TE Connectivity

Product Change Notification: PCN-25-254982

AMPSEAL Socket Terminal New Stamping Capacity Tool

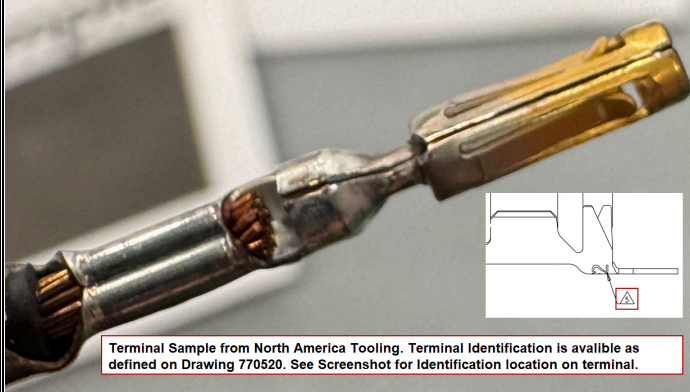
Terminal Sample from North America Tooling. Terminal Identification is available as defined on Drawing 770520. See Screenshot for Identification location on terminal.

Terminal Sample from new capacity tooling. Localized gold plating is present on terminal beams as defined in product drawing 770520.
